寄件者: Chong Hermose <[REDACTED]>
寄件日期: 2025年12月30日星期二 14:44
收件者: tpbpd/PLAND
副本: William Shu Tai WONG/PLAND
主旨: s16 : A/NE-MUP/220 -回應部門的意見 (請以此電郵為準**)
附件: DD 38 Lot 25 & 26_測量圖.pdf; DD38_25_Layout_Plan_20251230.pdf; 申請表格_P.5.pdf;
申請表格_P.11.pdf; 附件1 : A_NE-MUP_220_Temporary Drainage Proposal.pdf; 附件2 :
A_NE-MUP_220_FS Plan.pdf; 附件3.pdf; A_NE-MUP_220_回應部門意見_20251230.pdf
類別: Internet Email

**Temporary Logistics Centre and Associated Filling of Land
Various Lots and Adjoining Government Land, Sha Tau Kok, N.T.
(Application No. A/NE-MUP/220)**

Supplementary Information

Table A: Responses to Departmental Comments

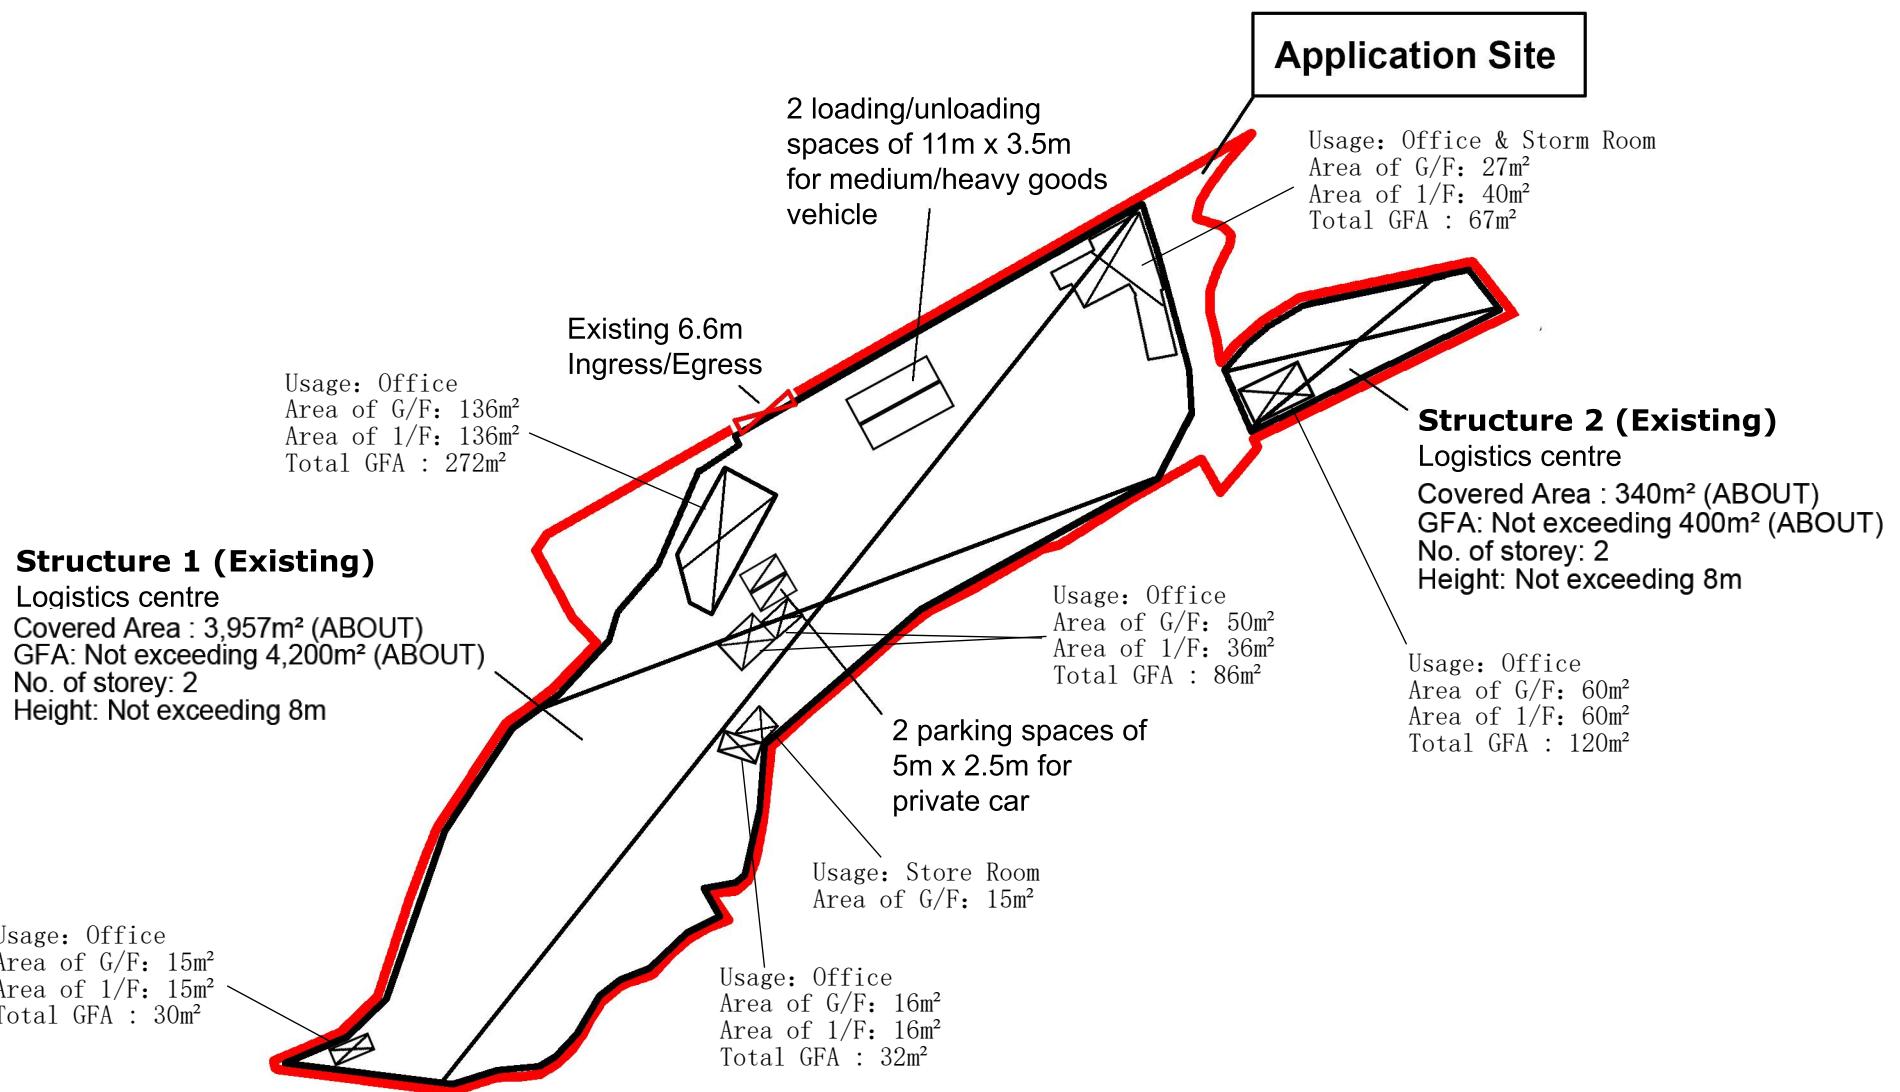
Departmental Comments	Responses
	Comment from EPD	
(1)	<p>It is noted that 6-8 staff will be working on the site during operating hours . The applicant should advise whether any sewage treatment facilities will be provided within the site and provide detailed information for their reference.</p>	申請地點內設有洗手間讓職員使用，也已設置化糞池，並會安排清潔公司定期來吸糞。
